Access Compliance Report

Public Rights-of-Way

(Curb Ramps)

Intersection ID: 43841	Main Street: DELUCA_DR	Cross Street: TAGGERT_CT	Location: SW
ADA ID: 112BA1A58E61	Ramp Type: PerpDiag	Initial Pass/Fail: Fail	Overall Compliance: No
Severity Score: 10			
Codes/Mitigation Info/Possible Solution		Field Measurements/Component Compliance

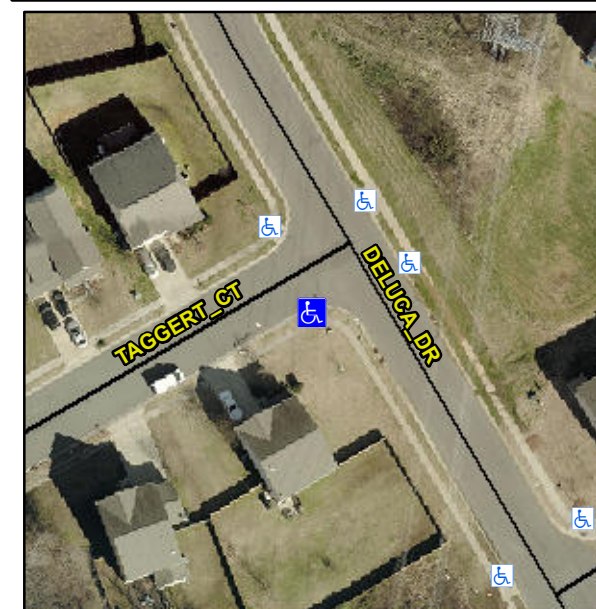
Not Found, R304.5.1, R304.5.3

Compliance	Description	Data	Compliance	Description	Data
N/A	Ramp Length (in)	45.5	Yes	Ramp Slope (%)	6.6
No	Ramp Width (in)	47.5	No	Ramp XSlope (%)	3.2
N/A	Flare Type LT	N/A	N/A	Flare Type RT	N/A
N/A	Flare Slope LT (%)	N/A	N/A	Flare Slope RT (%)	N/A
N/A	Flare Traversable LT?	N/A	N/A	Flare Traversable RT?	N/A
N/A	Landing Length (in)	N/A	N/A	DWS Provided?	N/A
N/A	Landing Width (in)	N/A	N/A	DWS Contrast?	N/A
N/A	Landing Slope (%)	N/A	N/A	DWS Length (in)	N/A
N/A	Landing X Slope (%)	N/A	N/A	DWS Full Width?	N/A
N/A	Landing Curb? (Y/N)	N/A	N/A	DWS Offset (in)	N/A
N/A	Shared Landing?	N/A			
N/A	Gutter Ponding?	N/A	N/A	Gutter Slope (%)	N/A
N/A	Gutter Lip Ht (in)	N/A	N/A	Gutter X Slope (%)	N/A
N/A	Painted X Walk1?	No	N/A	Painted X Walk2?	No
	X Walk 1 Direction	To E		X Walk 2 Direction	To N
N/A	X Walk 1 Width (in)	N/A	N/A	X Walk 2 Width (in)	N/A
	X Walk 1 Slope (%)	3.3		X Walk 2 Slope (%)	0.2
	X Walk 1 X Slope (%)	3.1		X Walk 2 X Slope (%)	1.5

N/A	Ramp inside XWalk1?	N/A	N/A	Ramp inside XWalk2?	N/A
	Road Slope (%)	1.0	N/A	Clear Space?	N/A
	Road X Slope (%)	4.6	N/A	Clear Space to XWalk (in)	N/A
N/A	Any Obstructions?	N/A	N/A	Storm Grate/Utility Hazard?	N/A
	Obstruction Type			Storm Grate/Utility Type	
		N/A			N/A
			Yes	Surface Condition? (G/P)	Good

Remove & Replace Curb Ramp With Two New Directional Ramps or Equivalent.
